Re: PLANNING APPLICATION No: DA0400/2019
Proposed Construction of Residential Dwelling by BVZ
Designs - (Lot 14) 83 Sanwae Drive, Swan Bay

# Re: 83 Sanwae Drive, Swan Bay, TAS 7252 APPLICATION NO: DA0400/2019

Residential - Construction of a dwelling

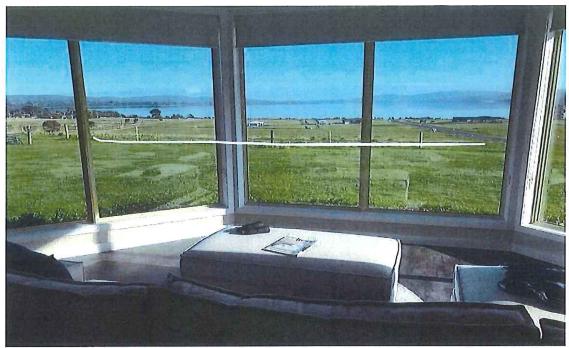
This image is taken from our main living room and I have drawn a line to show where our front

boundary fence is located. Should someone be allowed to build a 8m house (as allowed by the rural living zone requirements) and only 6.5m from this boundary line, we would lose all lifestyle and amenities (sunlight, outlook and privacy).
